## **RFP #889-20P Edwards Roof Replacement**

**Addendum 002  
Issued April 27, 2020**

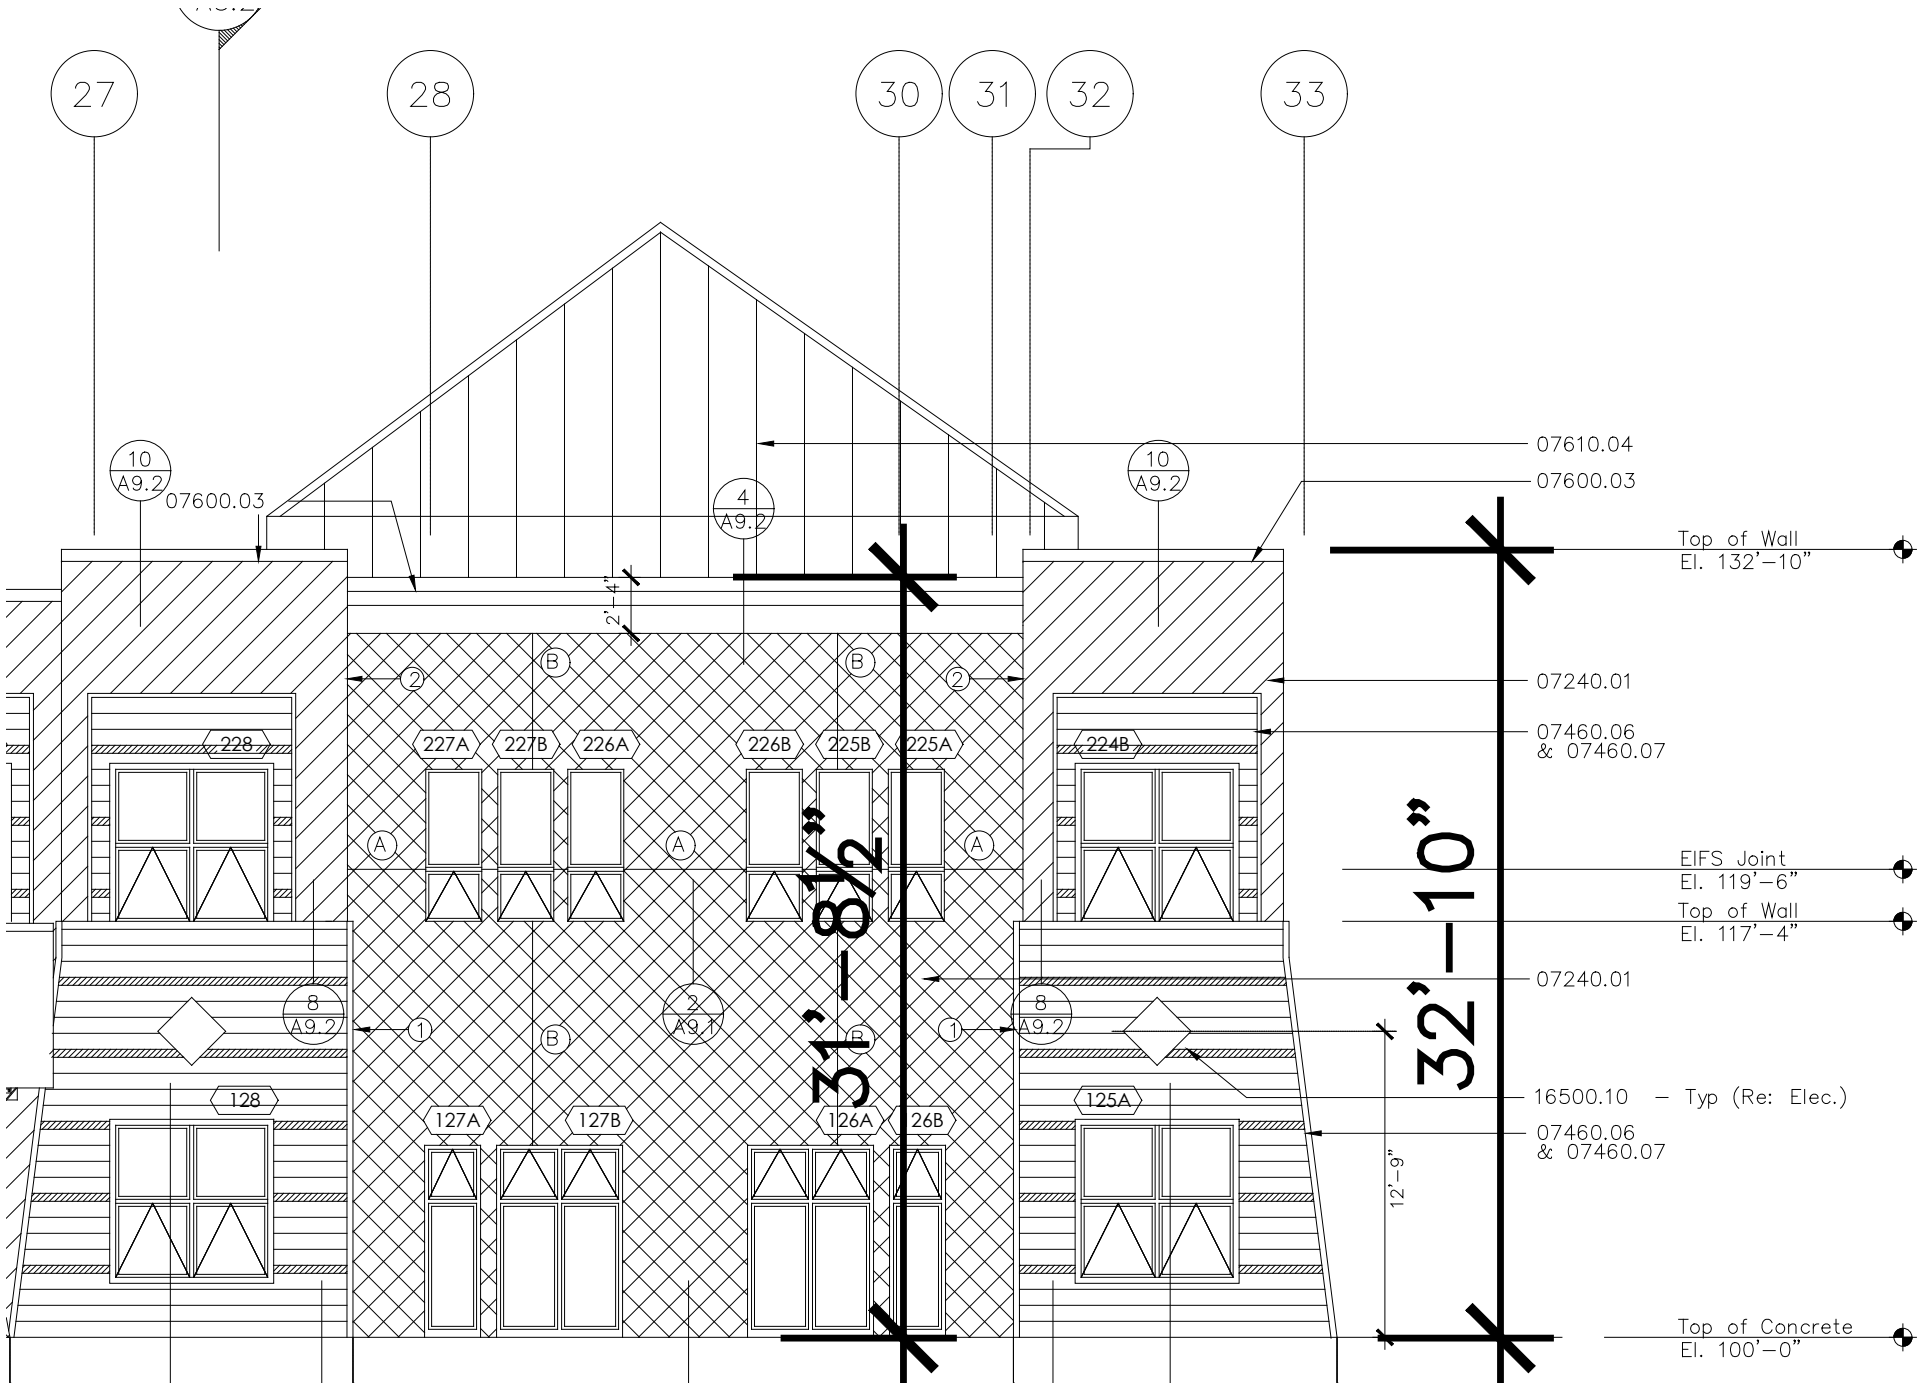
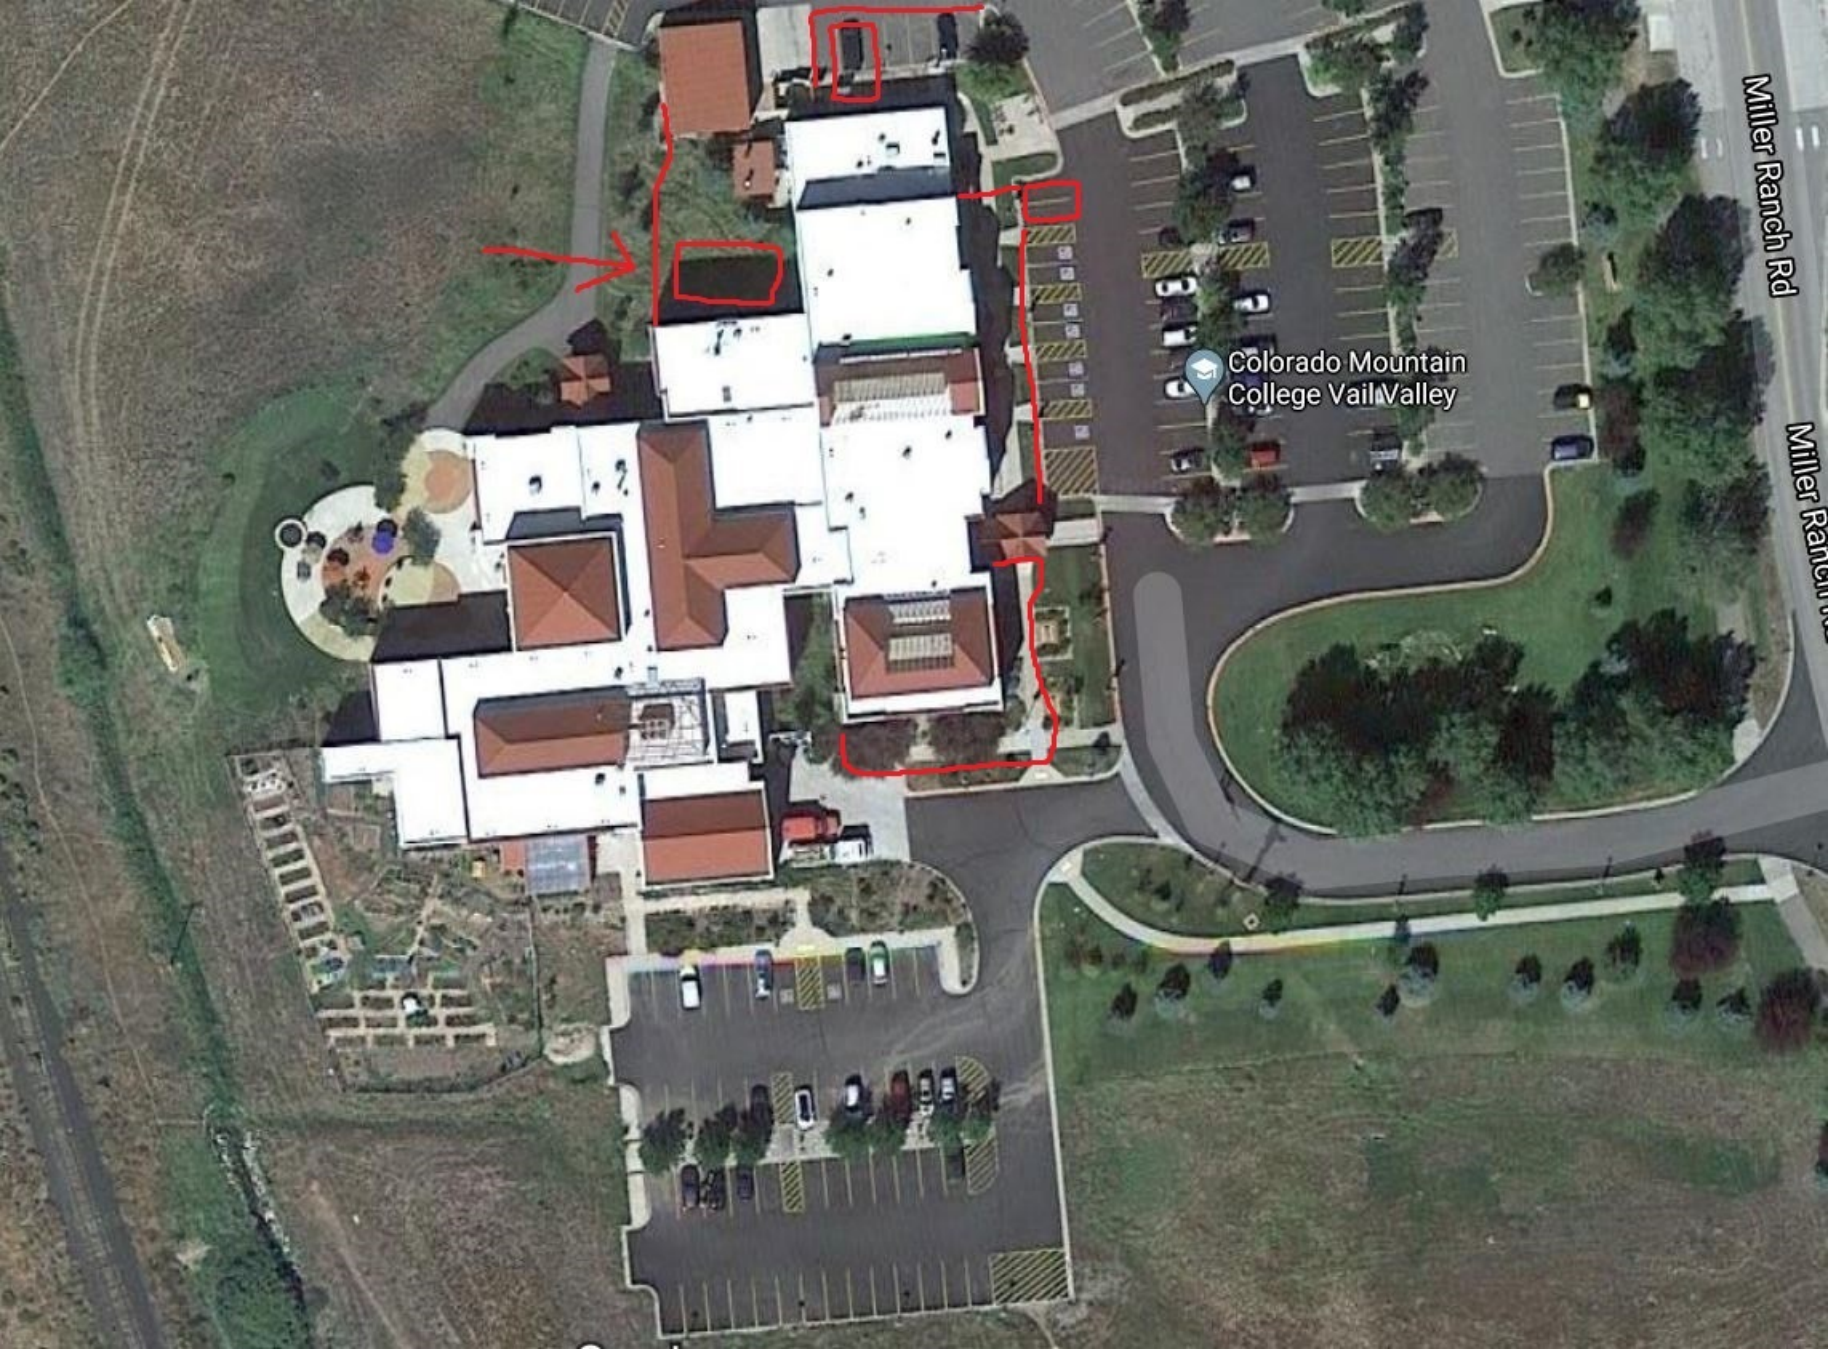
1. See attached South Side Parapet Heights.
2. Photos can be found at: <https://www.dropbox.com/sh/ano1cnfkef7edq0/AABVXJ6-0BUqXFT2MRf9Z4yKa?dl=0>
3. The attached aerial shows possible locations for the dumpster and where we may need fencing. CMC prefers the fencing and dumpsters be located on the north or west side so they don't hinder the sidewalk on the east side which is needed for ADA parking.
4. Mule-Hide Products white on black EDPM, matching or exceeding all specified characteristics, is an approved equal.
5. Contractors shall assume roof slope obtained structurally.
